Annotated Set with changes from DRB15-017 noted in red

DEL MAR CIVIC CENTER

MOD 16-002 CITY COUNCIL

Modifications (MOD16-002) to a previously-approved Design Review Permit (DRB15-017) for minor changes to the City Hall/Town Hall/Plaza Project. The requested modifications include the following: various design revisions to the building façade, windows and doors, and west parking garage elevation, Town Hall roof material, landscaping, and plaza layout and features; addition of antennas and exhaust shaft; revisions to floor plans and parking garage layout (one-story garage proposed in lieu of two-story design); reduction from 160 to 140 parking stalls; addition of a new stairwell and pedestrian garage access near 10th Street; removal of a patio, gate and fence; modification of a vehicle entry ramp on the south elevation; and addition of a vehicle access between the garage and surface parking lot on the internal west elevation.

1 PLAZA LEVEL - FLOOR PLAN
1" = 20'-0"

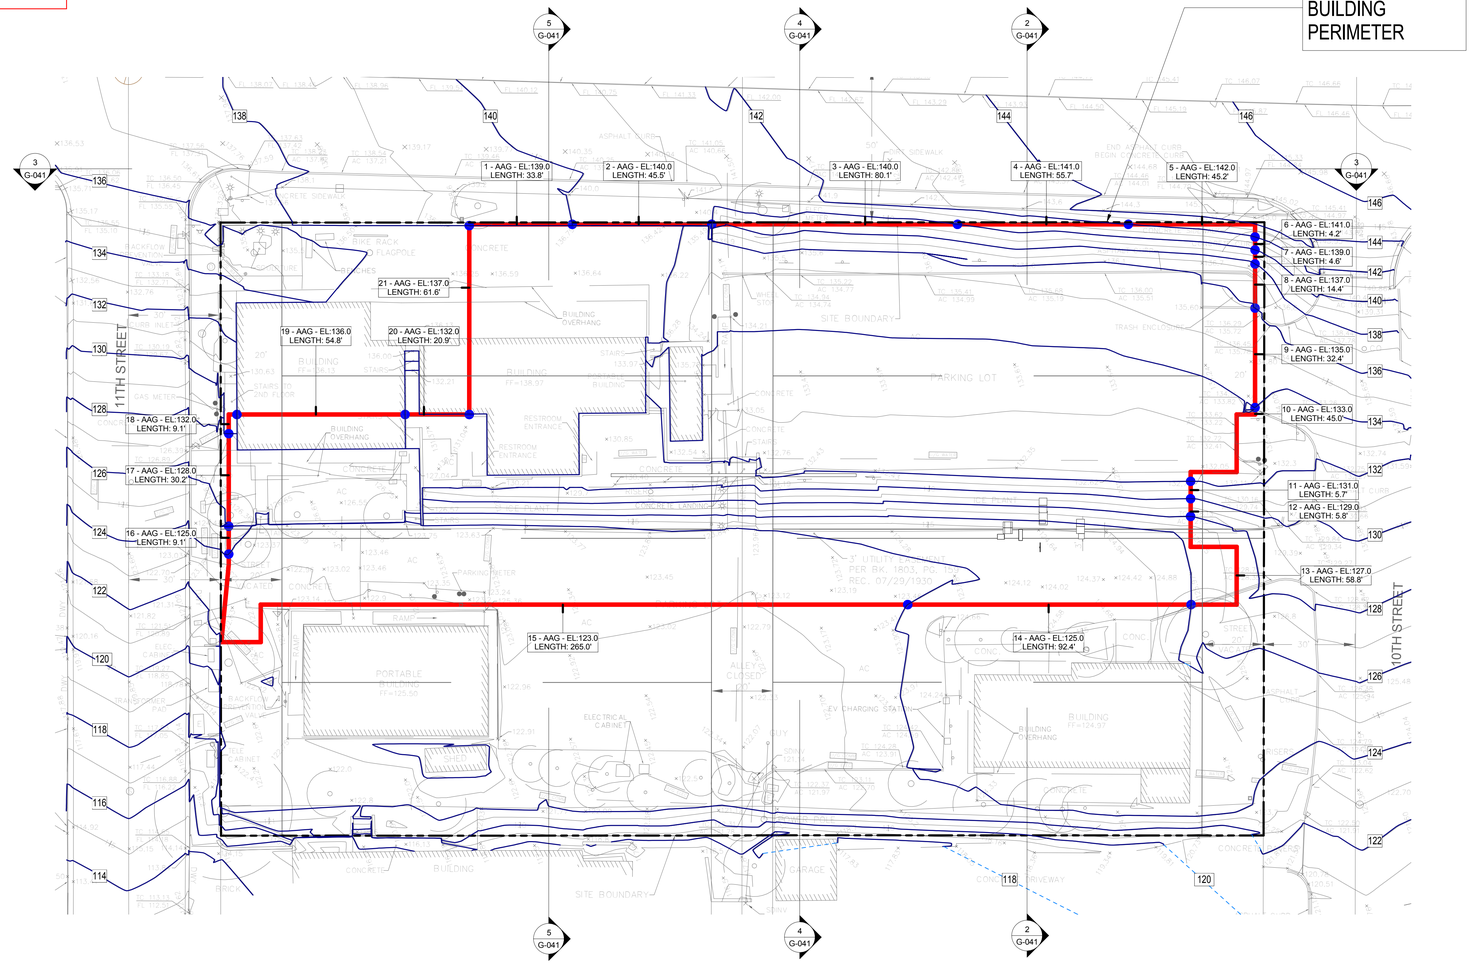
Average Adjoining Grade Calculations are revised to depict single level garage footprint

C-101

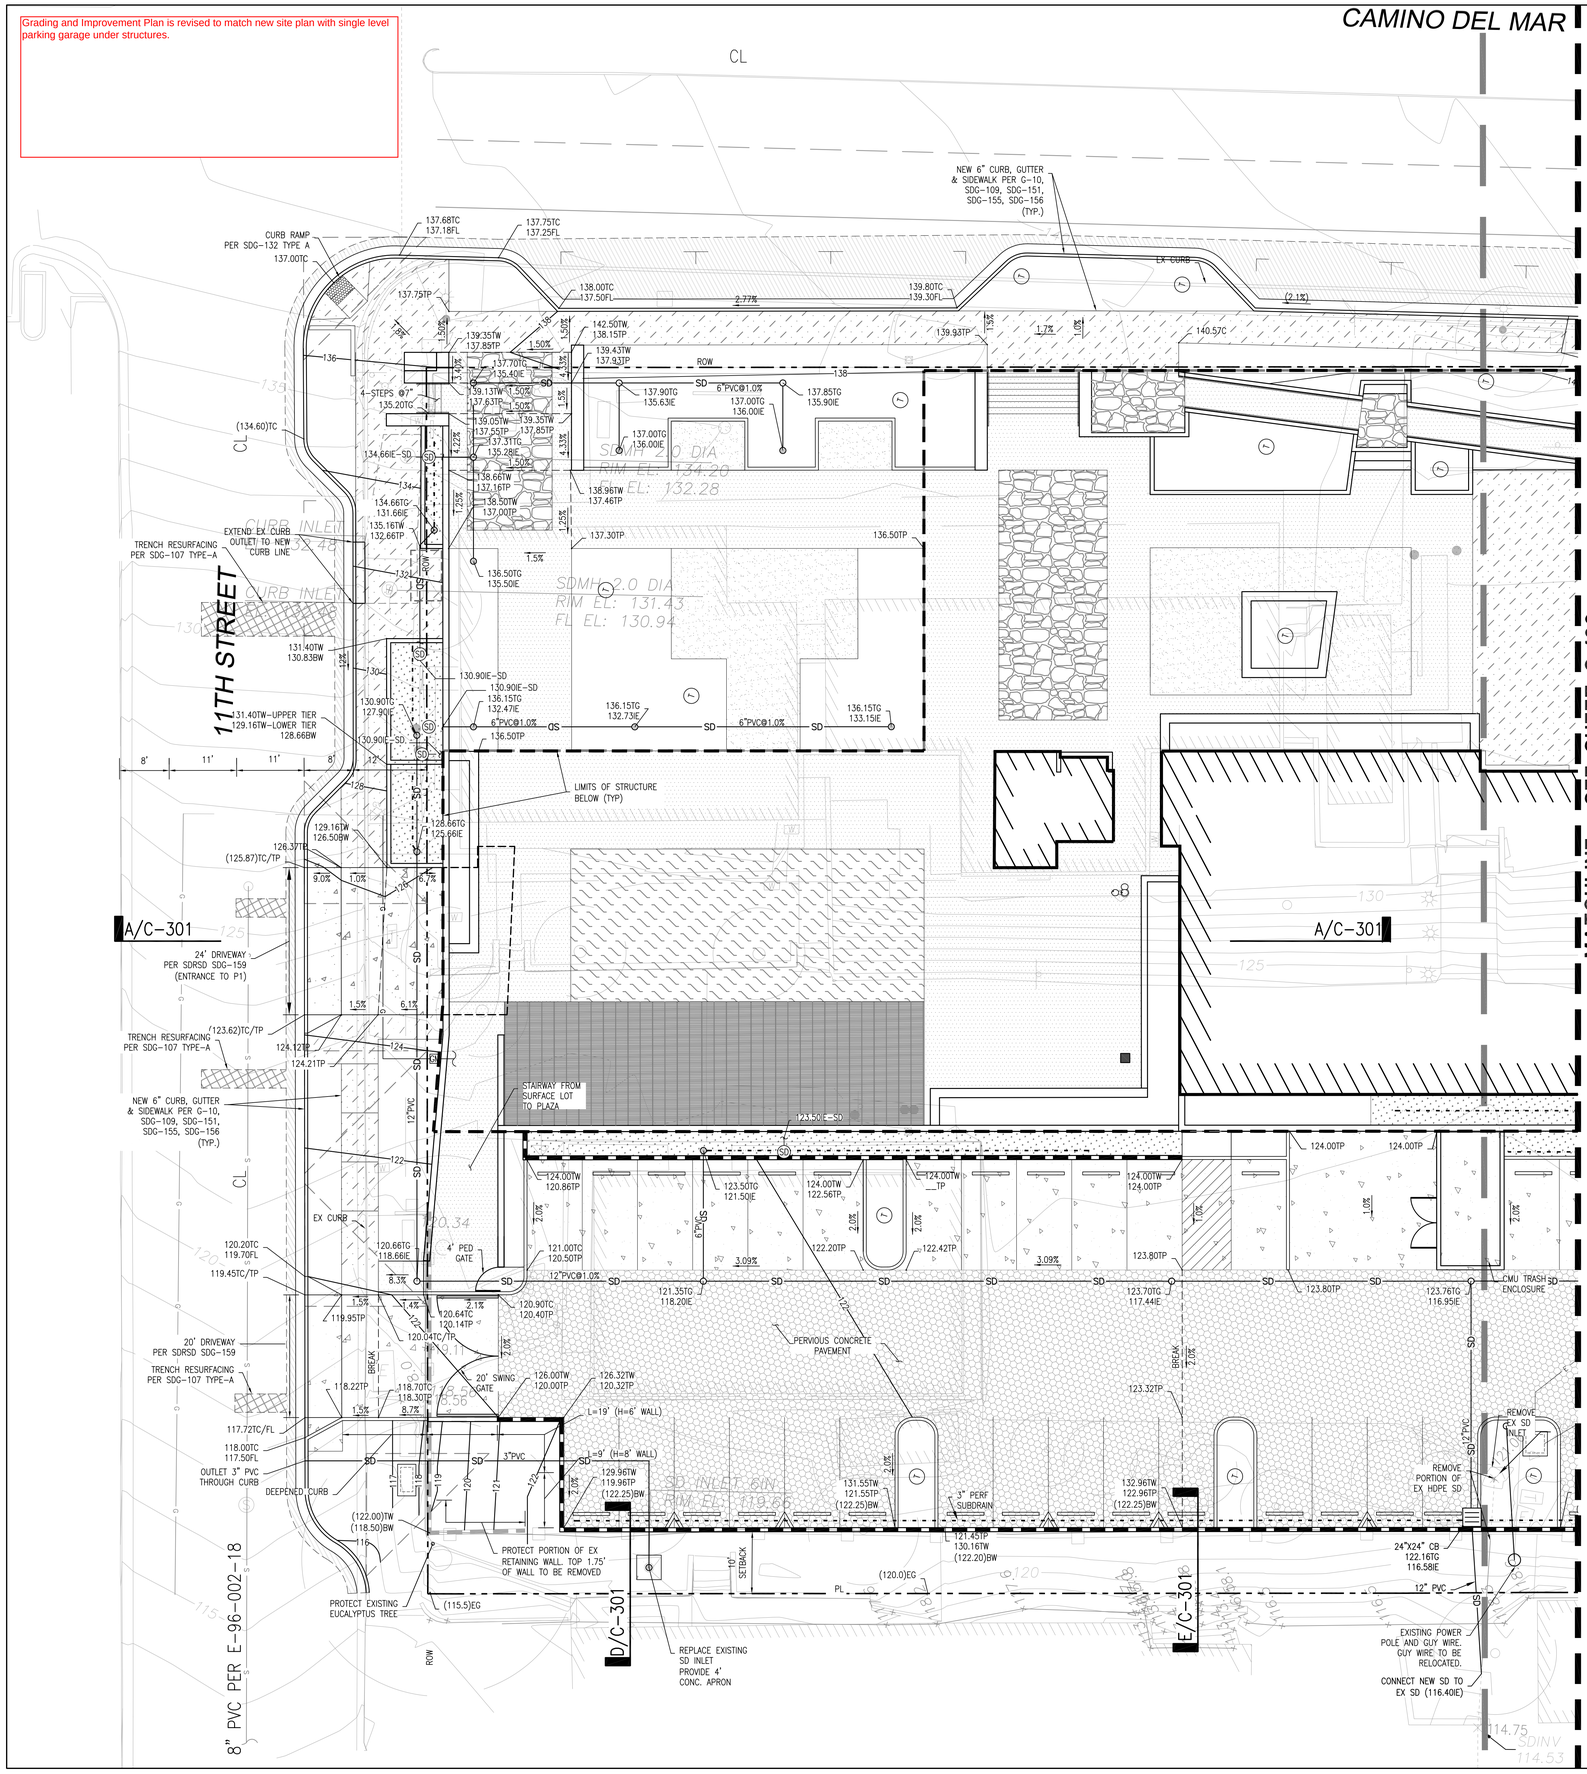
Grading and Improvement Plan is revised to match new site plan with single level parking garage under structures.

C-102

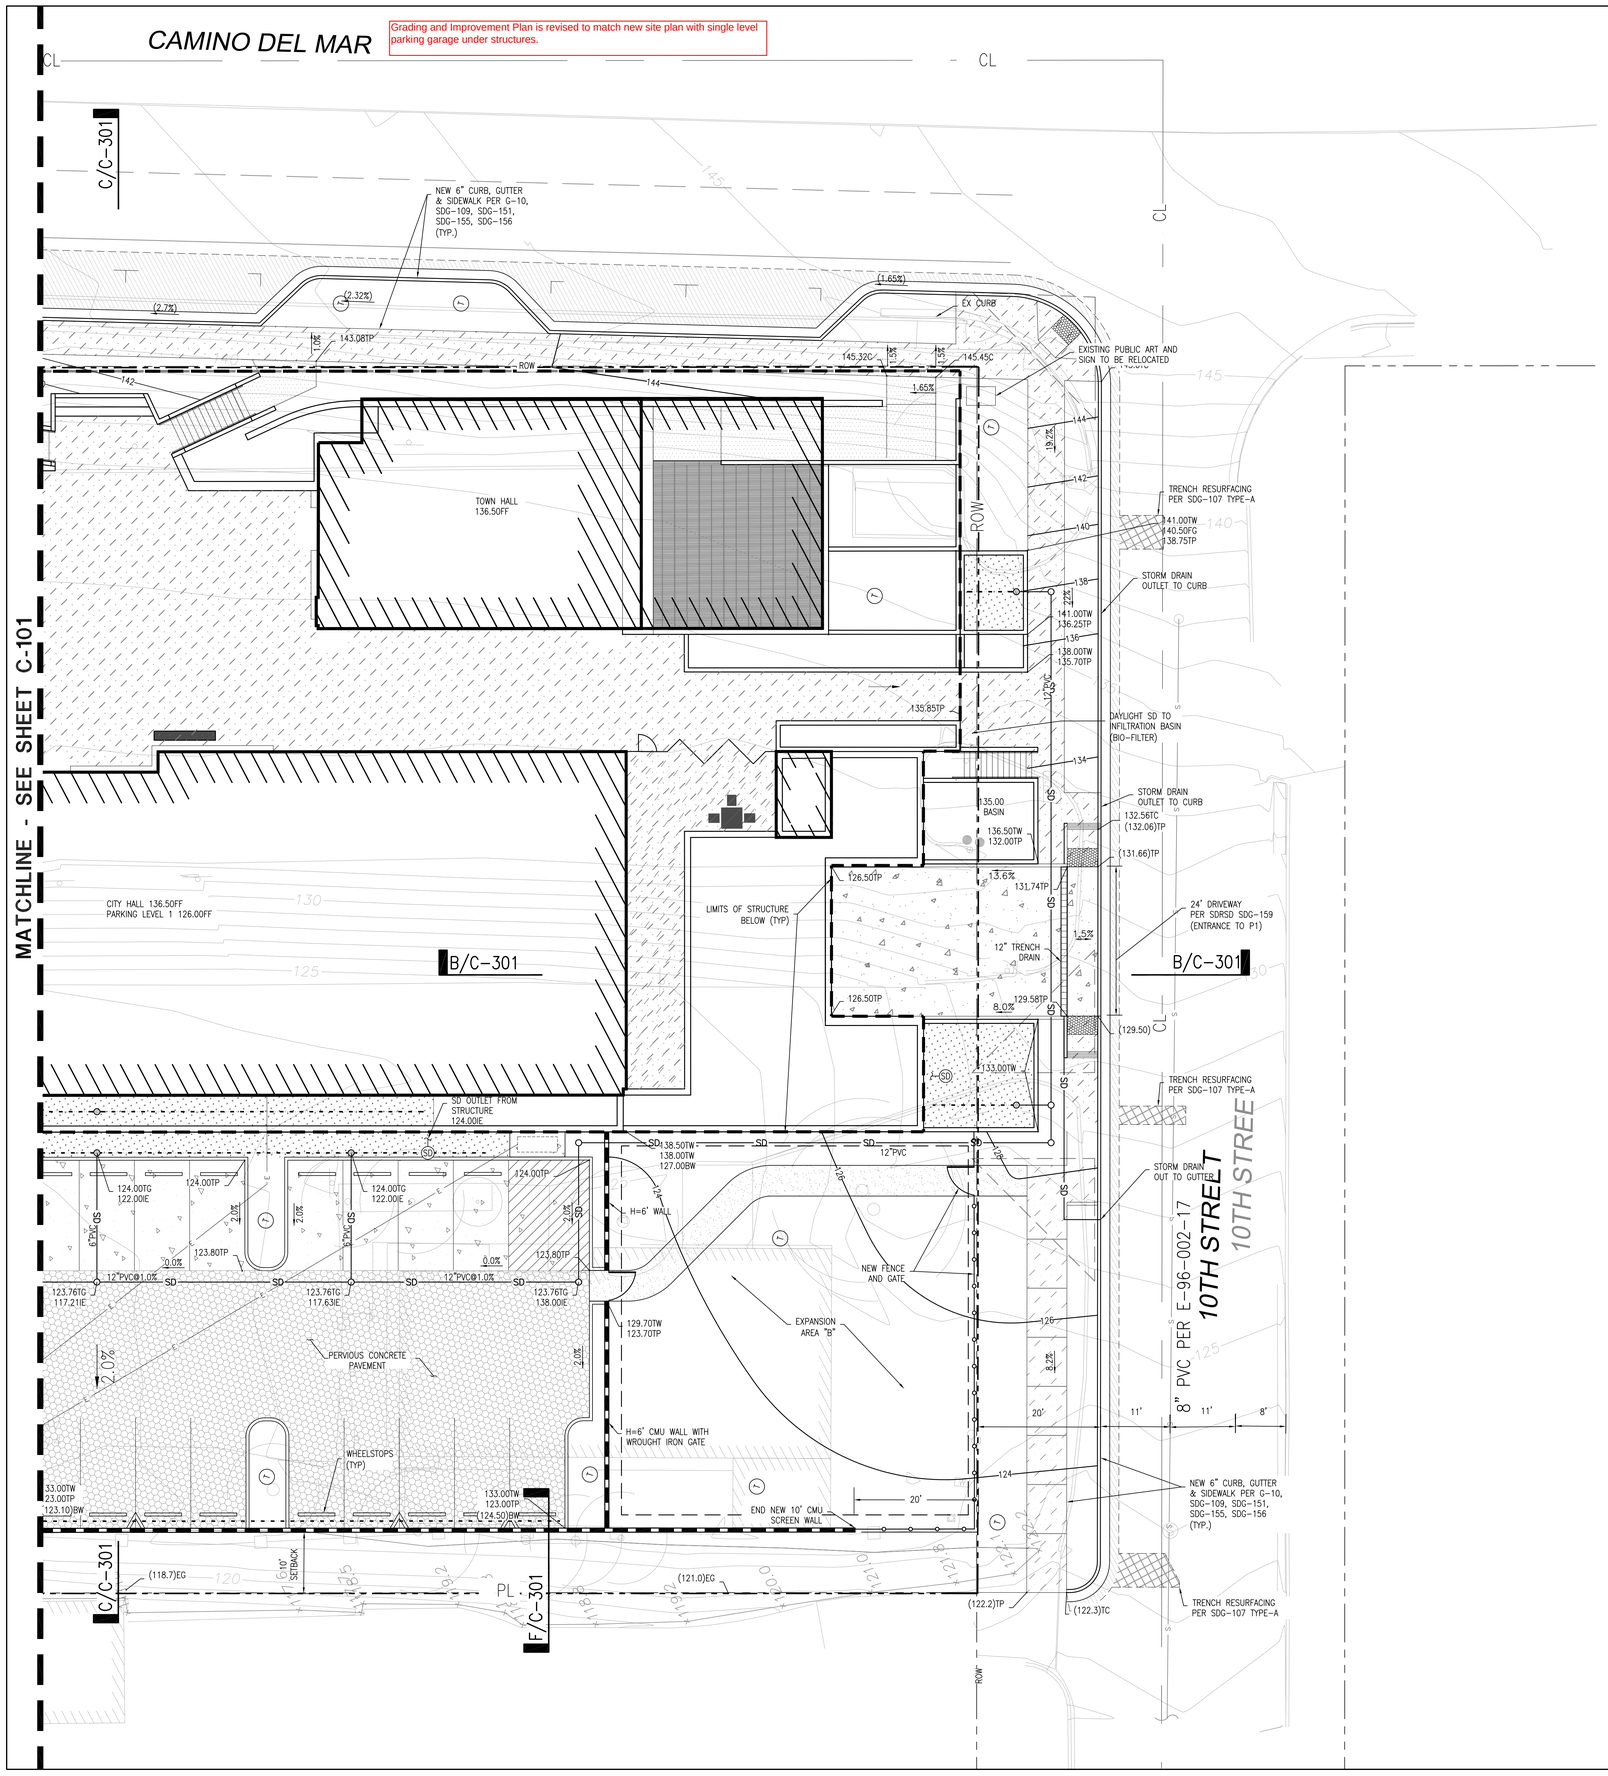
Grading and Improvement Plan is revised to match new site plan with single level parking garage under structures.

A-102

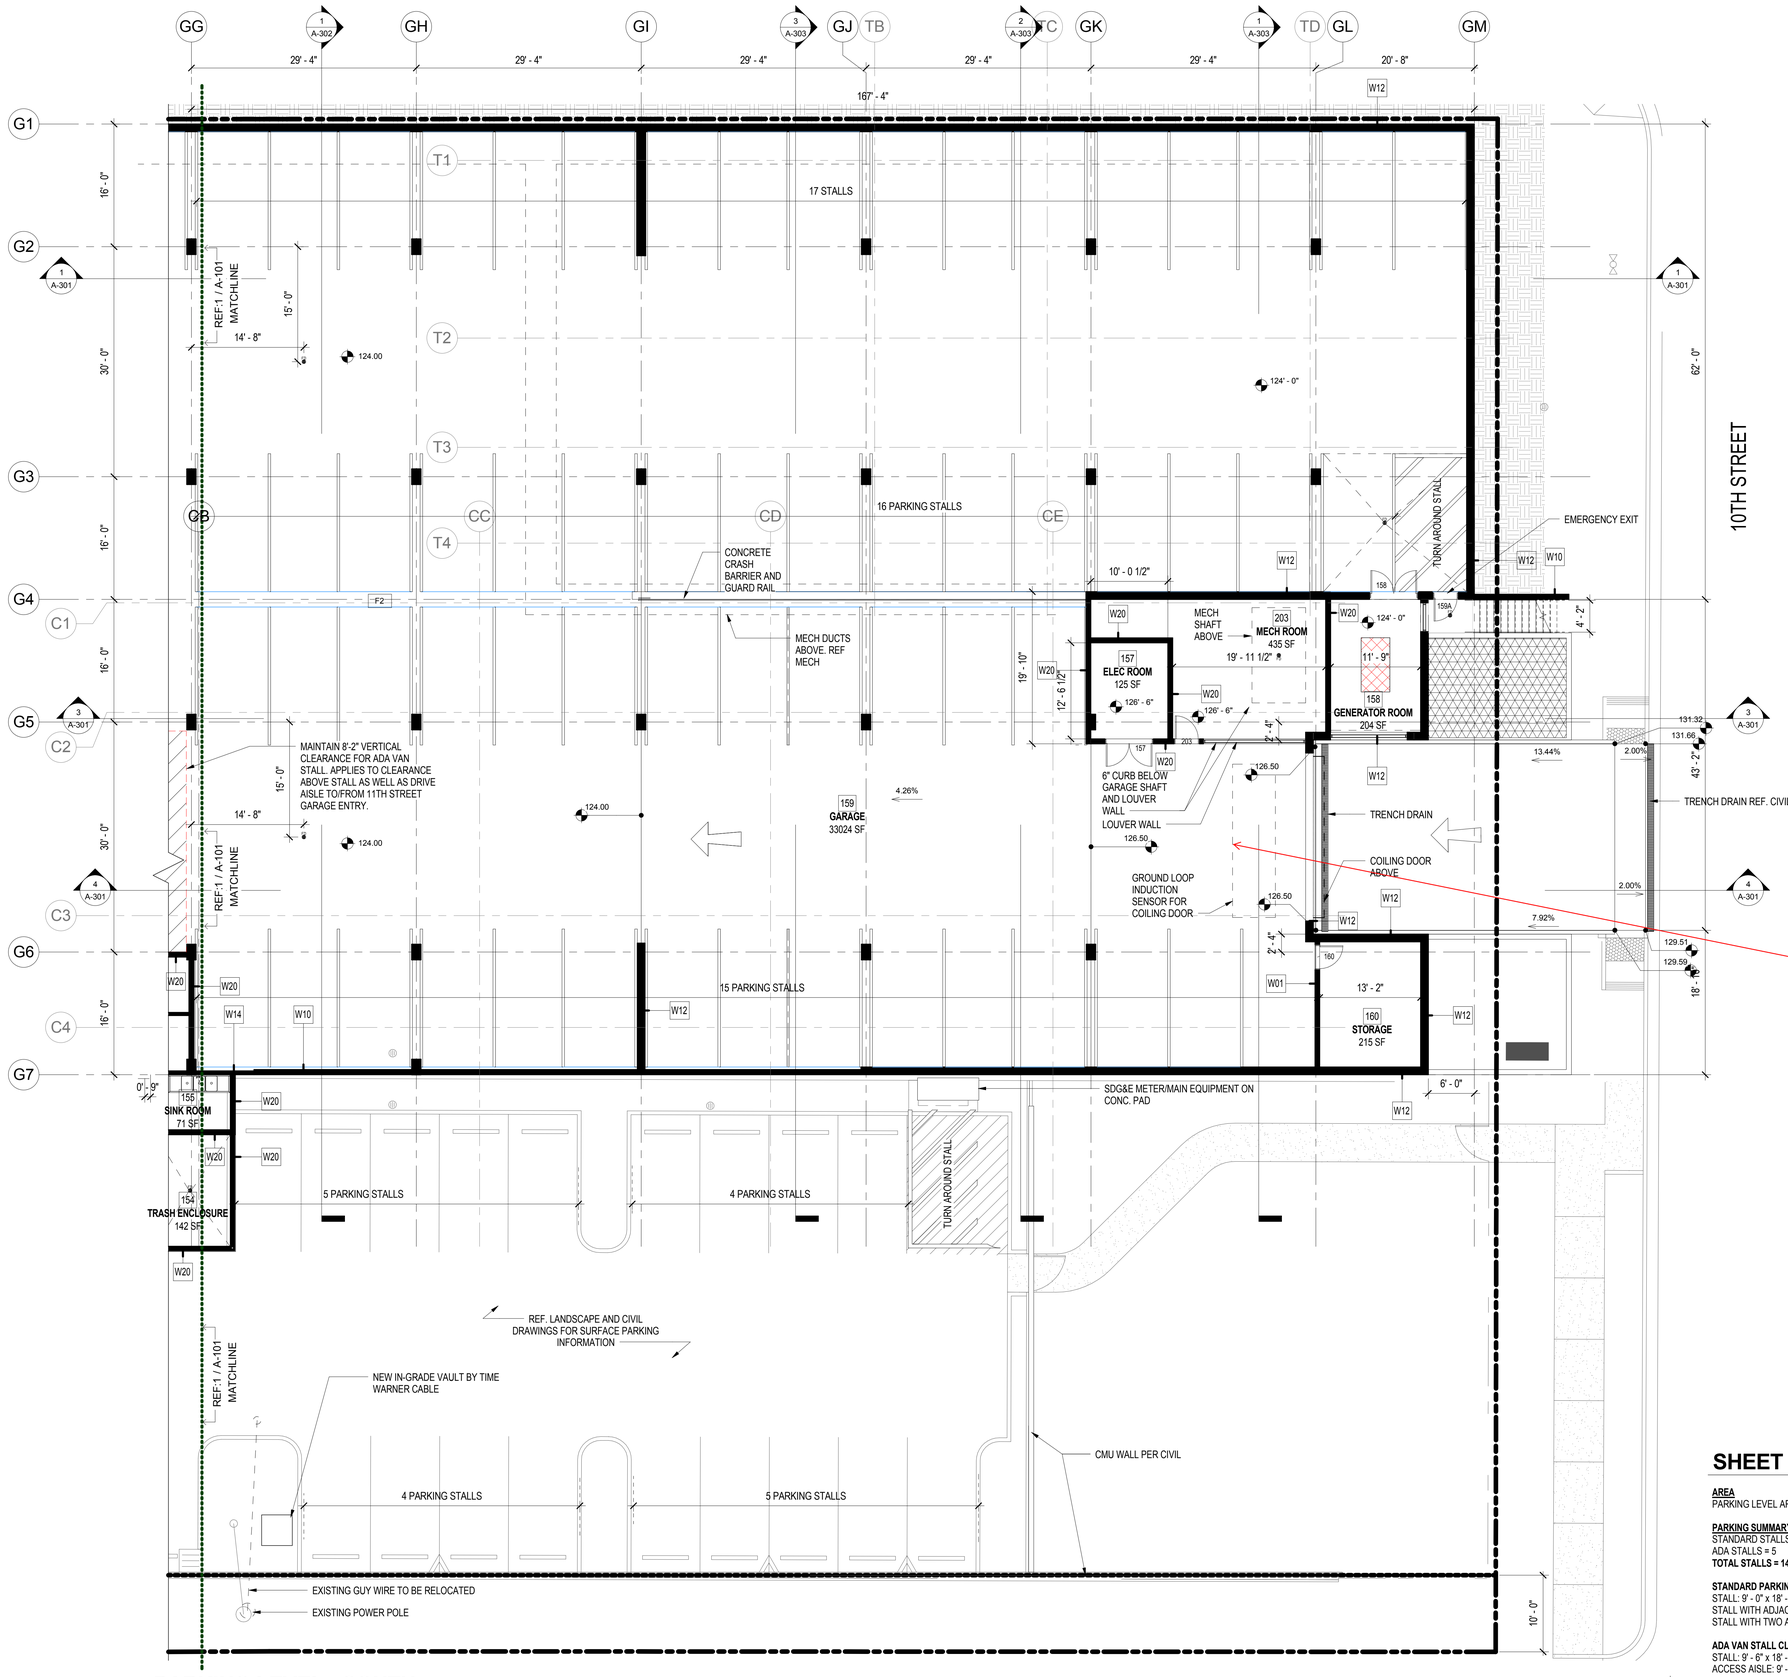
Entire garage redesigned to be on one level under grade, and eliminates lower level and its ramp. Expands garage to the east under Commons and Town Hall, adds exit stairs to 10th Street. Electric Vehicle stalls added. Mechanical room and storage rearranged. 10th Street entry reconfigured for driveway to be easterly, and allow for special event or emergency egress if needed, per DRB15-017 approval hearing.

3 WEST SITE ELEVATION

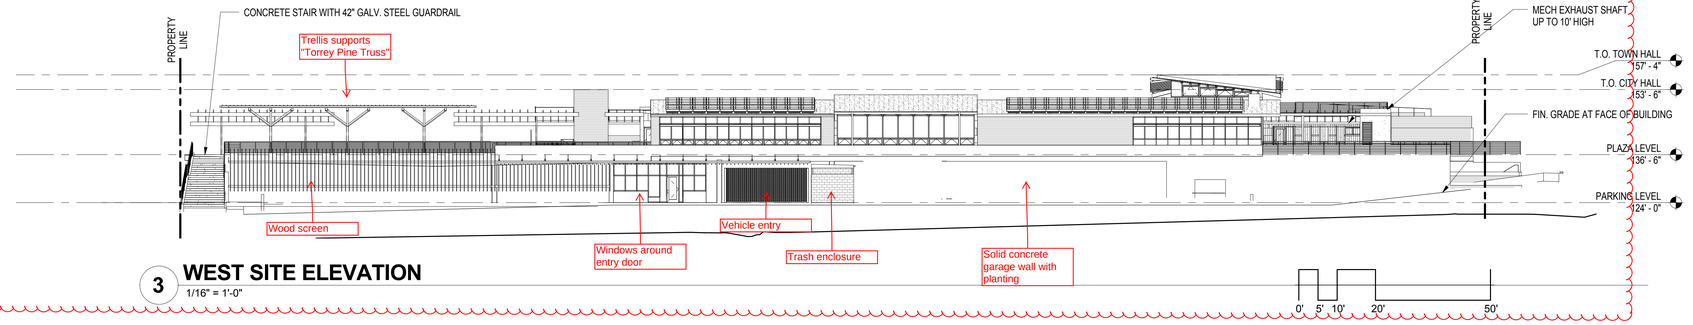
West site elevation modified at the garage level to show solid structure garage wall (for noise and light attenuation); eliminates applied precast panels. Adds wood trim on northern portion of garage wall to correspond to Ocean View Terrace above. Addition of storefront glazing at disabled/ pedestrian entry to be more inviting; addition of garage entry vehicle door as stipulated in DRB15-017 approval hearing; modification to trellis structure supports on Ocean View Terrace.
